**DIRECTORATE GENERAL OF HYDROCARBONS**  
(Ministry of Petroleum & Natural Gas)  
OIDB Bhawan, Plot No. 2, Sector 73, Noida -201 301.  
Phone: +91-120-2472000 Email: mm@dghindia.gov.in

Corrigendum No. 1 to tender no. **MM-12014(12)/1/2018-DGH/ENQ-128** for supply, installation, and commissioning of Virtual Reality Centre at DGH Noida

**This corrigendum is issued to amend technical specifications, Bid evaluation criteria, Special Conditions of Contract, extend bid closing/opening date and to provide DGH's response to pre-bid queries.**

Fig 1

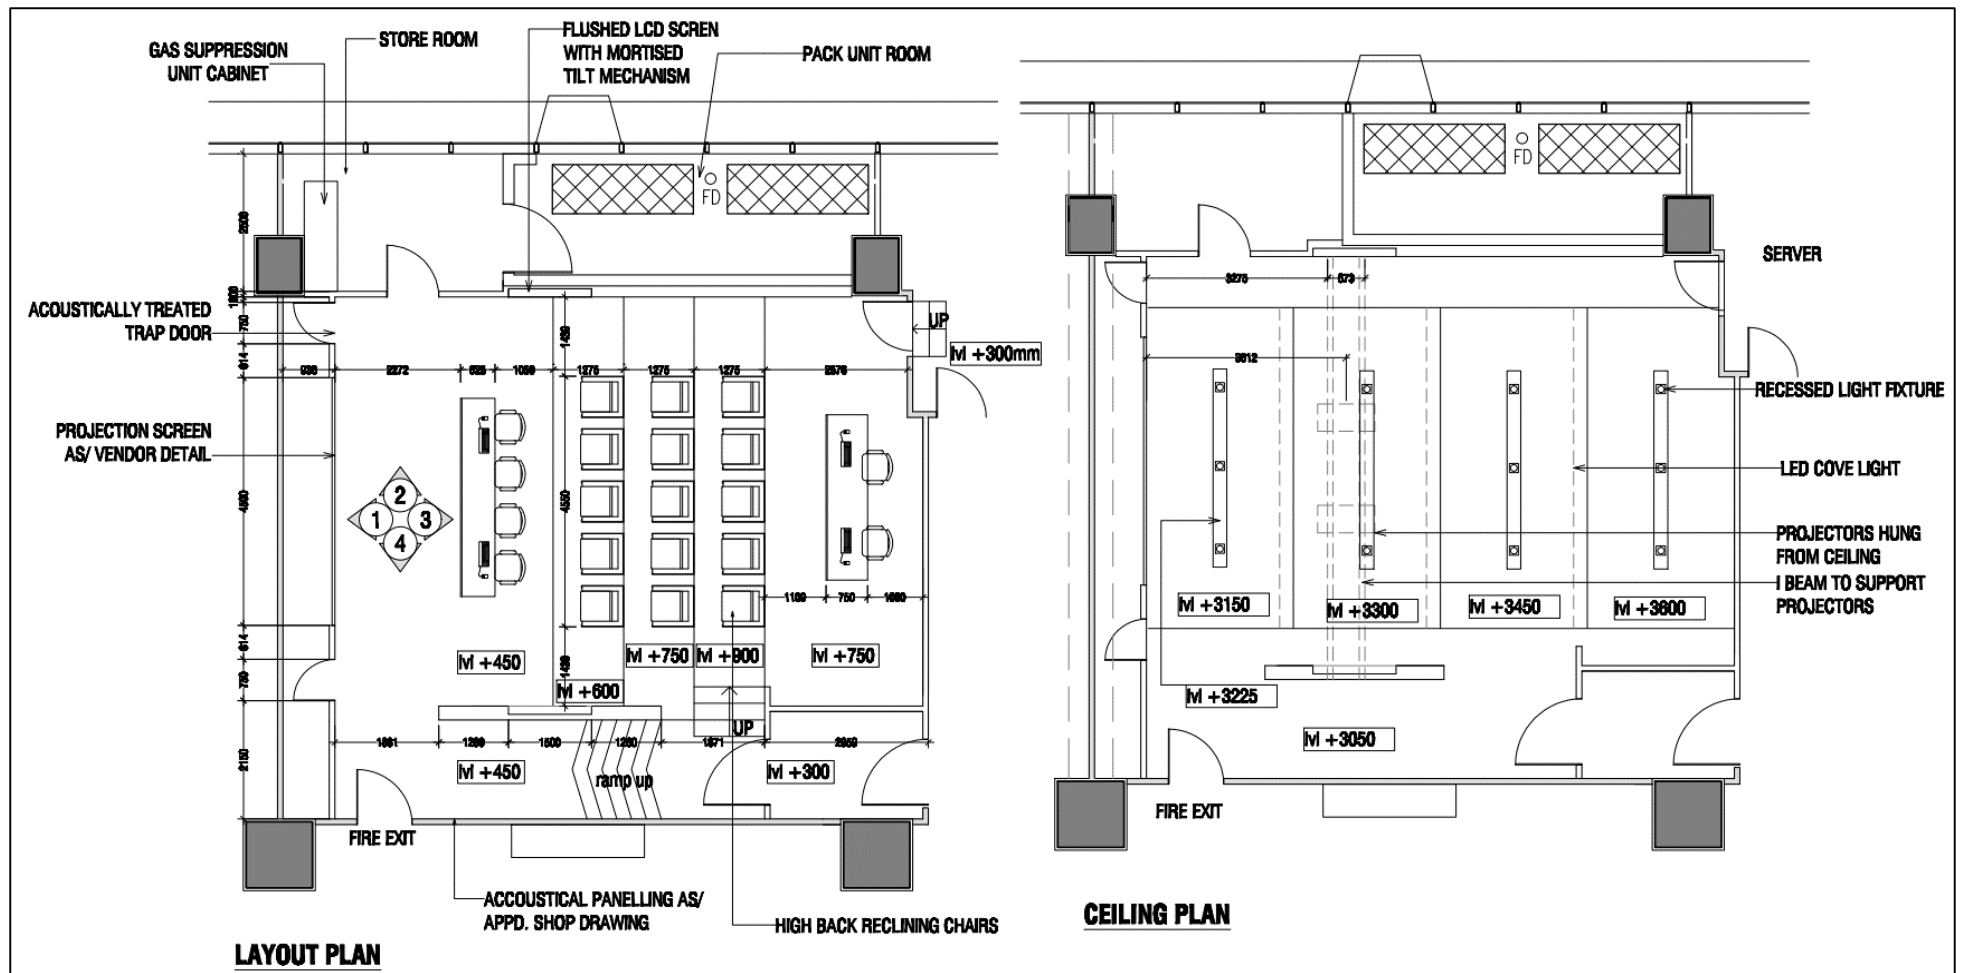
10	Clause 4 of annexure - IV	<p>a. All Interior work including acoustic panelling for providing separation of Display System from audience for isolation of back-end noise, light fixtures, electrical/network points.</p> <p>b. All civil work or its supervision, including but not limited to creation of wall opening for screens, finishing around screen or any decorations for the interiors of the room, false ceiling/ flooring, wall modification, water proofing, gas-based fire proofing, seating arrangement, floor levelling, network installation, cabling baskets/conduits etc.</p> <p>c. Removal and disposal of existing equipment, associated items &amp; packaging material</p> <p>d. Covering the carpet/room equipment during screen painting.</p> <p>e. Installation of any equipment/cables etc. not specifically mentioned in the tender but are required for completion of the project must be supplied and installed by the bidder.</p> <p>f. Installation of cabling baskets or computer floor to cover cabling</p> <p>g. Any equipment &amp; labourers for hoisting the material like crane, manpower etc. must be arranged by the bidder.</p>	<p>a. All Interior work including acoustic panelling for providing separation of Display System from audience for isolation of back-end noise, light fixtures, electrical/network points.</p> <p>b. All civil work or its supervision, including but not limited to creation of wall opening for screens, finishing around screen or any decorations for the interiors of the room, false ceiling/ flooring, wall modification, water proofing, gas-based fire proofing, <u>seating arrangement for atleast 25 persons with single seater movable executive chairs with desk arm, presentation podium, dedicated desk for pilot station,</u> floor levelling, network installation, cabling baskets/conduits etc.</p> <p>c. Removal and disposal of existing equipment, associated items &amp; packaging material</p> <p>d. Covering the carpet/room equipment during screen painting. (if applicable)</p> <p>e. <b><u>Installation of any equipment/ cables/ interior work/ civil work etc. not specifically mentioned in the tender but are required for completion of the project must be supplied and installed by the bidder.</u></b></p> <p>f. Installation of cabling baskets or computer floor to cover cabling</p> <p>g. Any equipment &amp; labourers for hoisting the material like crane, manpower etc. must be arranged by the bidder.</p> <p>h. <u>Existing lay-out of VRC is attached vide Fig 1 &amp; 2.</u></p>
